**Re: REQUEST FOR ADMINISTRATIVE APPROVAL OF
MINOR CHANGES TO APPROVED MASTER PLAN**
Subject Property: 571 Main Street, A.P. 56-3, Lot 137
Applicant/Owner: Roland J. Fiore
Zoning District: RM (Residential Multi-Household District)
**Use Code: 12.1 (Sec. 301) Multi-Household Land
 Development Project**

Amended Master Plan Submission

571 Main Street

Amended Master Plan Submission

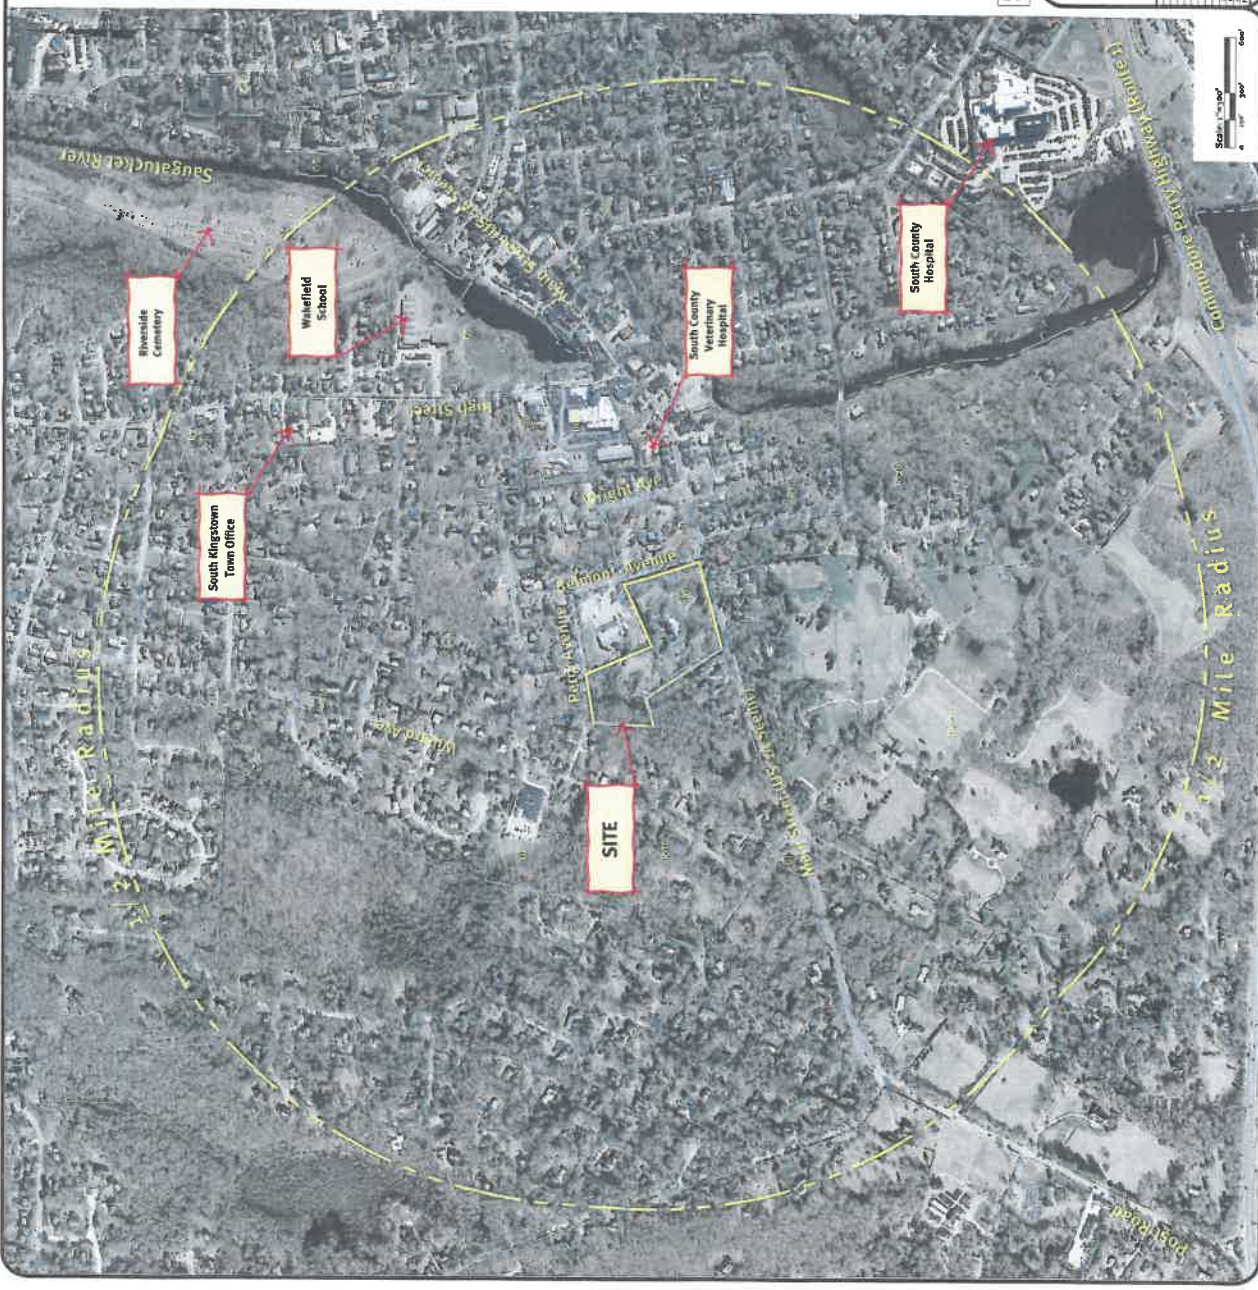
As set forth more fully below, the existing Master Plan approval is for thirty six (36) dwelling units. The proposed Amended Master Plan is for the same number (*i.e.*, 36): Thirty two (32) condominium units, plus four (4) units within the existing main house, as previously approved. The existing approved 100' front setback and 25' side setbacks will be maintained from Main Street and Belmont Street, respectively. The proposal remains fully compliant with

existing zoning after the Amendment. Total impervious area for the approved Master Plan was 94,879 SF. The proposed changes reduce it to 86,243 SF. Lot coverage for the approved Master Plan was 28.4%. The proposed changes reduce it to 25.8%. The open space calculation for the approved Master Plan was 239,507 SF (5.50 +/- acres). The proposed changes increase it to 248,243 SF (5.70 +/- acres). The approved master plan provided for ten (10) three (3) bedroom units and twenty six (26) two (2) bedroom units (including the four units in the main house). The proposed changes make all the units two (2) bedroom units, reducing the bedroom count by ten (10). Inasmuch as the density for Multi-Household Land Development Projects is 4.3 units per acre for three (3) bedroom units, and 7.71 units per acre for two (2) bedroom units (Land Dev. and Subdiv. Regs, Art. IV H (2)(b)), the proposed reduction of ten (10) three (3) bedroom units to ten (10) two (2) bedroom units renders the project density significantly less than what would be permitted by the Regulations, and what was previously approved.

The previously proposed and approved rows of garage units (36 garages in 6 "car barn" buildings) are also being eliminated, increasing the setback areas between the proposed development and the abutting Elks Lodge property, which abuts the subject property to the west (in part) and north (in part), resulting in a less cluttered site.

The northwest quadrant of the site will have its access, egress, and utility connections via a repositioning of the internal roadway's connection with Perry Avenue (a 50' public right of way). The new sewer connection, at the applicant's expense, should be a welcome resource for existing Perry Avenue area properties.
